**STAFF REPORT**  
**COMMUNITY DEVELOPMENT DEPARTMENT**

SUBJECT: Farmstone Crossing Subdivision AZ, PP  
[H-2023-0045](#)

LOCATION: 820 S. Black Cat Road in the Northwest ¼ of the Southwest ¼ of Section 15, T.3N. R.1W.

FIGURE 1

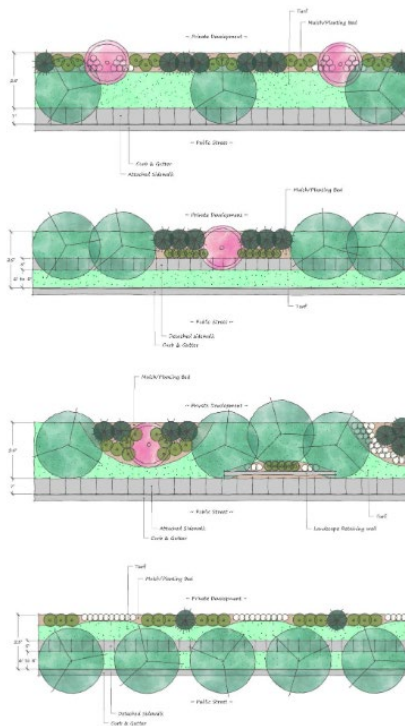
*The Applicant should revise the landscape plan to reflect landscaping within the required buffers along Vanguard Way and Black Cat Road adjacent to the drainage swale in front of the 10-foot pathway in accordance with the standards listed in UDC [11-3B-7](#), which requires a variety of trees, shrubs, lawn or other vegetative groundcover (see figures below).*

- a. Depict landscaping within required street buffers along Black Cat Road adjacent to the drainage swale in front of the 10-foot pathway and Vanguard Way in accord with the recently amended standards listed in UDC [11-3B-7C](#) and [11-3B-8C](#); all required landscape buffers along streets shall be designed and planted with a variety of trees, shrubs, lawn, or other vegetative ground cover. Plant materials in conjunction with site design shall elicit design principles including rhythm, repetition, balance, and focal elements

## D. Landscape Plan Rendering

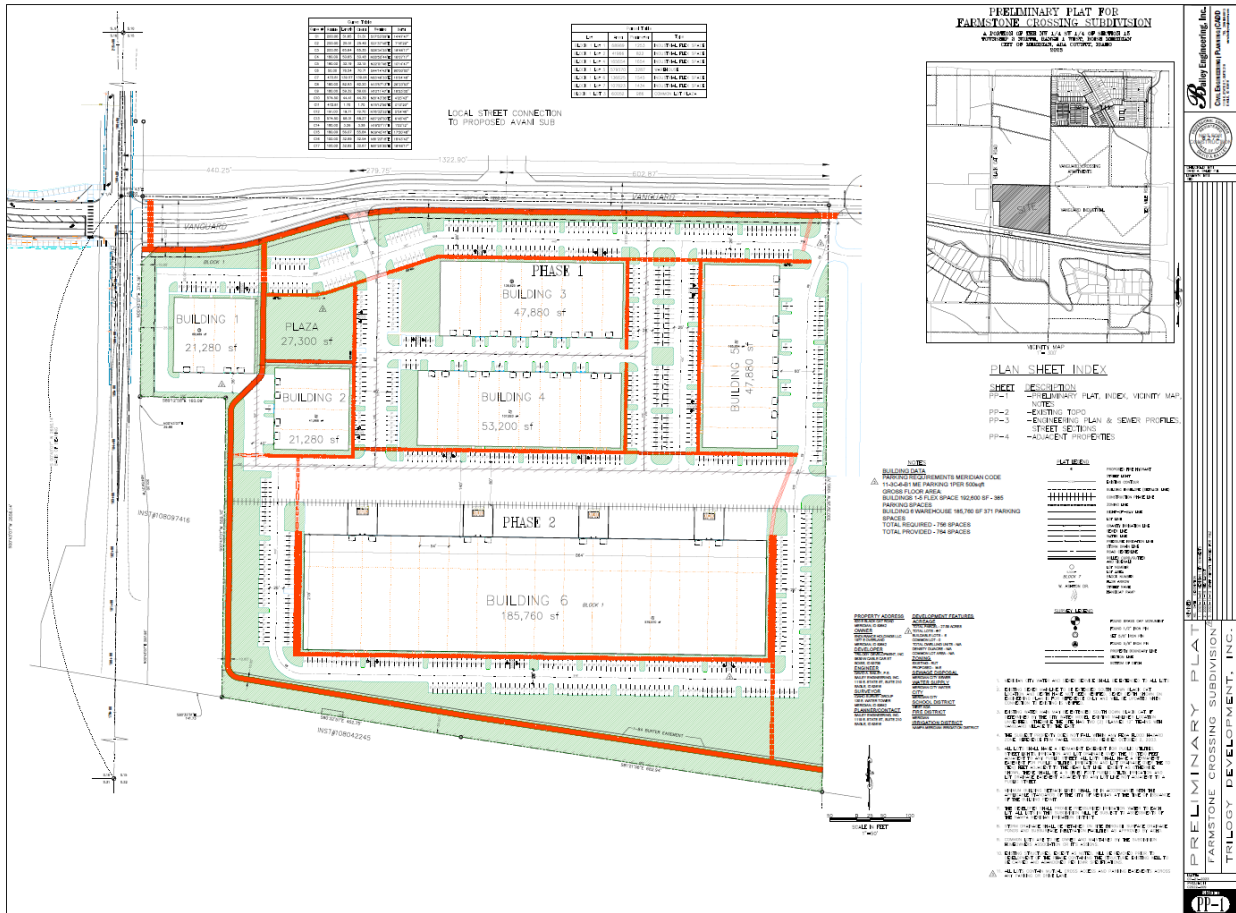
The Applicant proposes a plaza area between Building #1 and Building #2, featuring benches, a pergola, landscaping, and a potential historical monument of the existing silo on the site.

Mitigation is required for all existing trees 4” caliper or greater that are removed from the site in accord with the standards in UDC 11-3B-10C.5. Mitigation calculations are depicted on the landscape plan in accord with UDC standards (i.e. 149 trees at 2 caliper inches each for a total of 284 caliper inches). **The location of mitigation trees shall be depicted on a revised landscape plan submitted with the final plat application.**

- c. The location of mitigation trees shall be depicted on a revised landscape plan submitted with the final plat application.
- 2.4 A 14-foot wide public use easement for the multi-use pathways within this site shall be submitted to the Planning Division prior to submittal for City Engineer signature on the final plat(s).

## F. Conceptual Building Elevations for Buildings 1 - 5

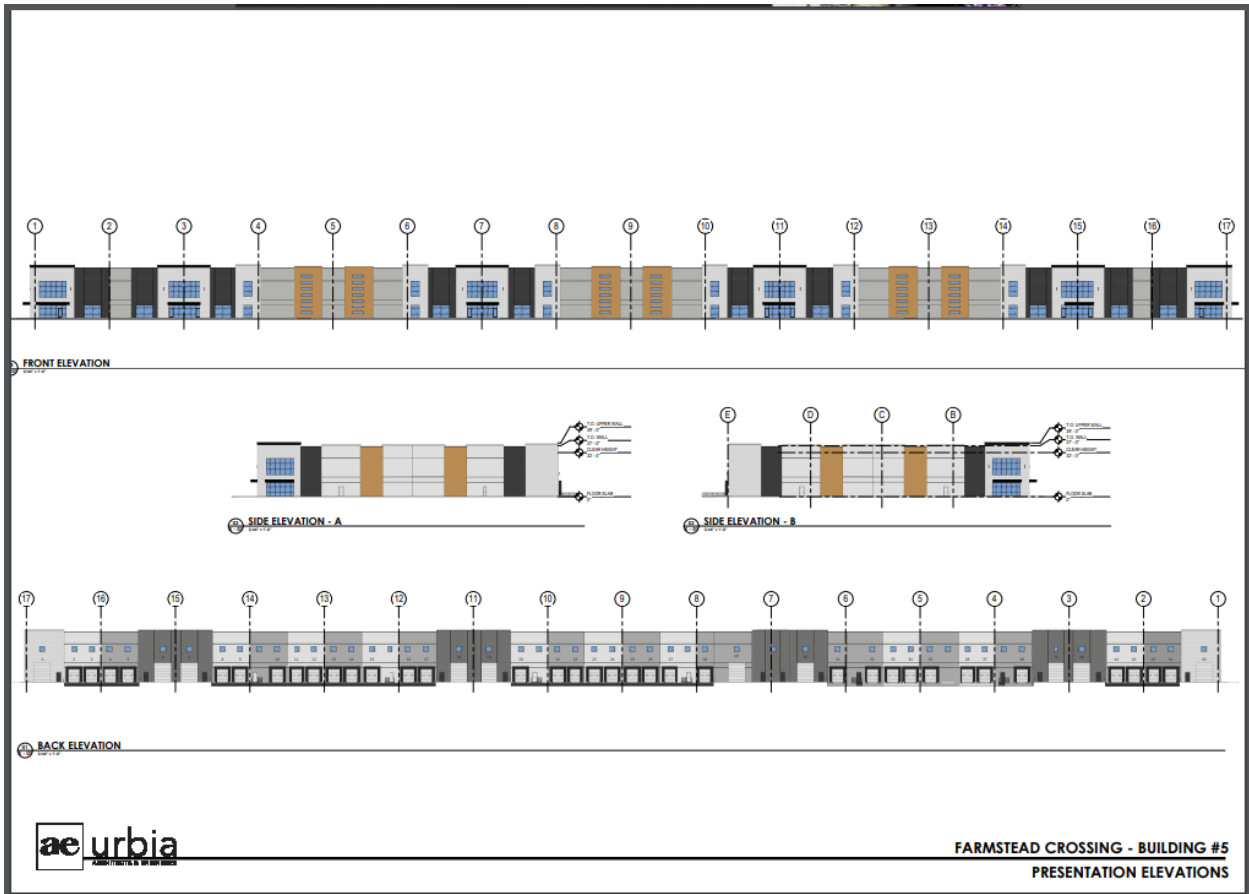
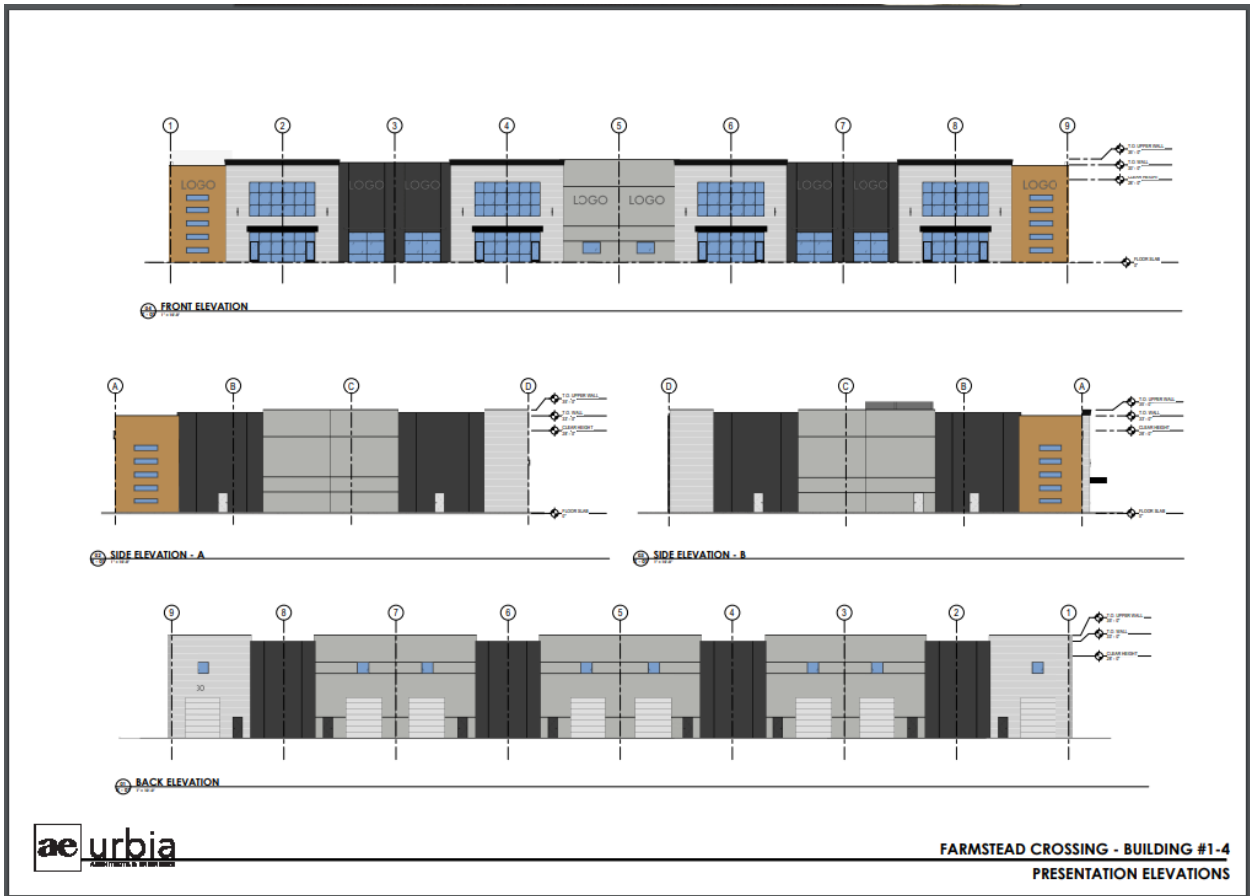
Conceptual building elevations were submitted for the proposed flex buildings and light industrial building as shown in Section VII.F. Building materials consist of horizontal metal or Hardie plank siding in white, wood colors; stucco in dark and light gray colors; metal awnings; and gray wrapped cornice moulding.

**The proposed conceptual elevations are *not* approved. Final design must comply with the design standards in the Architectural Standards Manual (ASM) and the design guidelines in the TMISAP for the Commercial designation (see the matrix for Application of the Design Elements on pg. 3-49). A Certificate of Zoning Compliance and Design Review application is required to be submitted for approval of the site and building design prior to submittal of building permit applications.**
